# ORIGINATION FORM

Index Number: **676-010**  
Sheet Number (s): 1 of 1  
Index Title: Cabinet Installation Details

Updated Notes; Reorganized Sheet; Added optional conduit to the concrete pole.

POLE MOUNTED CABINET

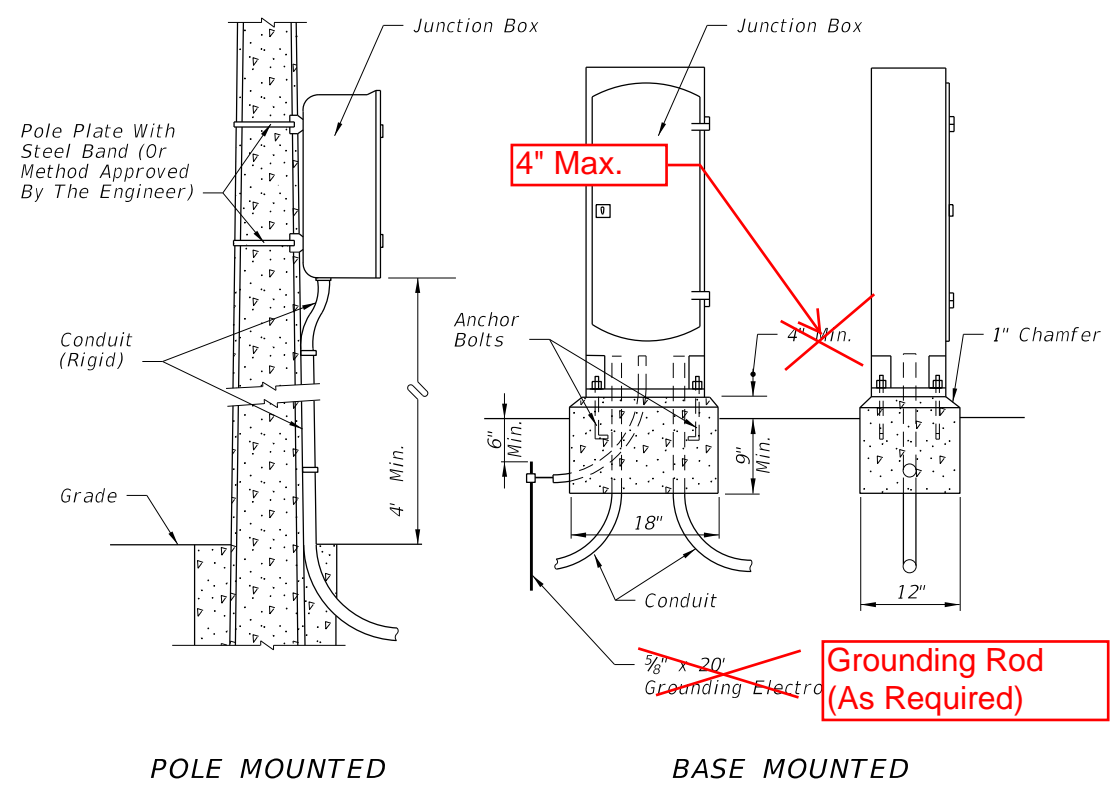
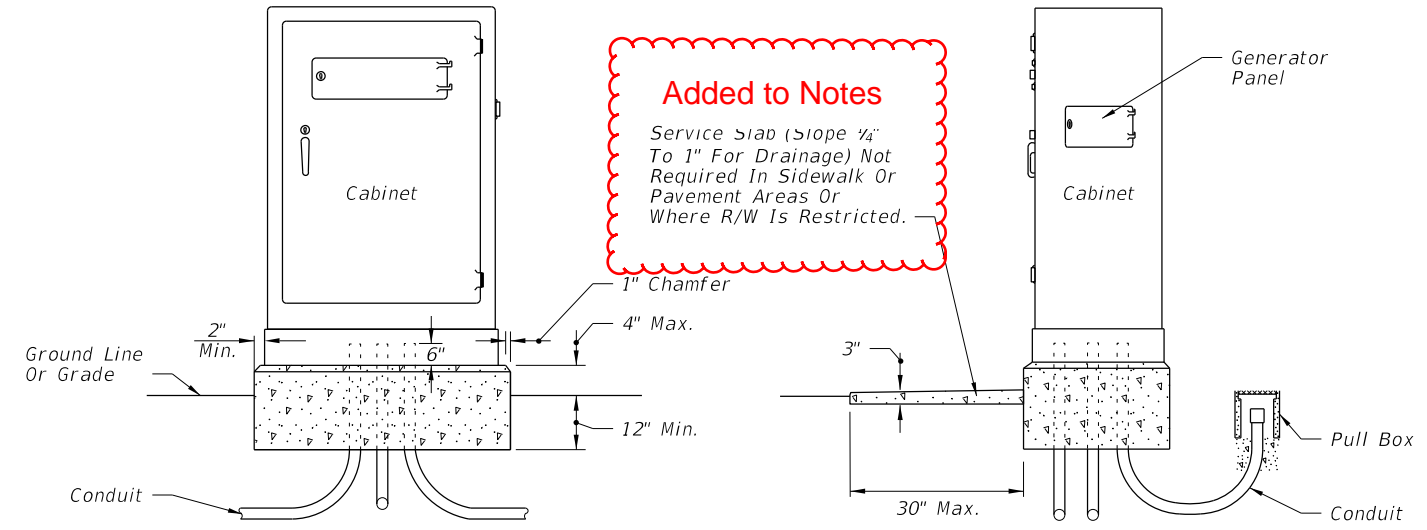
Liquidtight flexible conduit is approved for use from the electrical disconnect to the cabinet when both are installed on the same pole. **Added to Notes**

\* If holes for cabinet mounting require relocation, original holes shall be filled in with concrete or covered with a noncorrosive cover plate.

NEW CONTROLLER CABINET

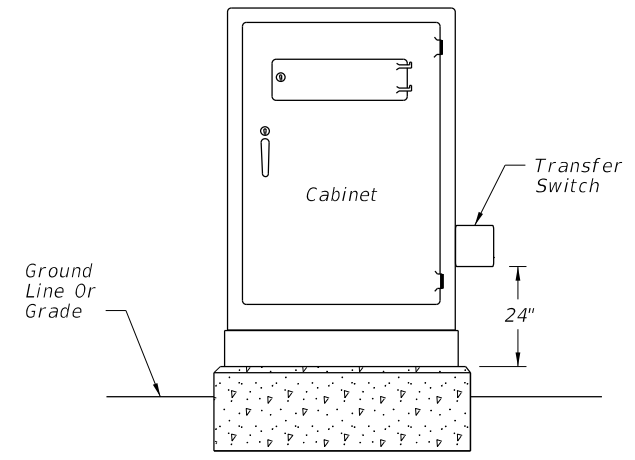
- The number, size and orientation of conduit sweep will vary according to site condition or locations. Two spare 2" PVC conduits shall be provided in all bases. The spares shall exit in the direction of the center rear of the cabinet base, into a pullbox and capped with a weathertight fitting. If obstructions prevent the spare conduit from exiting to the rear, or the rear of the cabinet is not available, the exit of the spare conduits will have to be approved by the project engineer. **Updated to Notes**
- Meet all grounding requirements of the Standard Specifications 620.
- New Controller Cabinet installation shall meet the requirements of the Standard Specifications 676.

EXISTING CONTROLLER CABINET

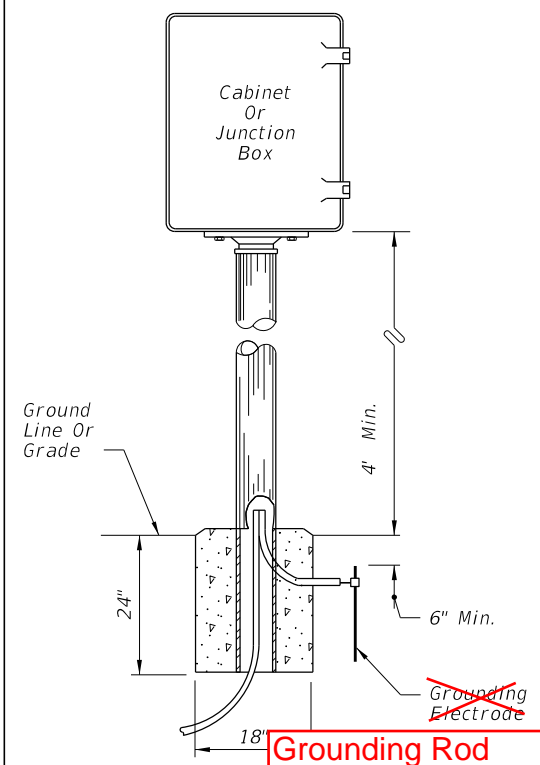
- Existing controller cabinets to be retrofitted shall meet the requirements of the Standard Specifications 678.
- The signalized **Updated to Notes** cabinet retrofit installation procedure is available at [http://www.fdot.gov/Traffic/Doc\\_Library/Doc\\_Library.shtm](http://www.fdot.gov/Traffic/Doc_Library/Doc_Library.shtm) for Generator Power for Signalized Intersection
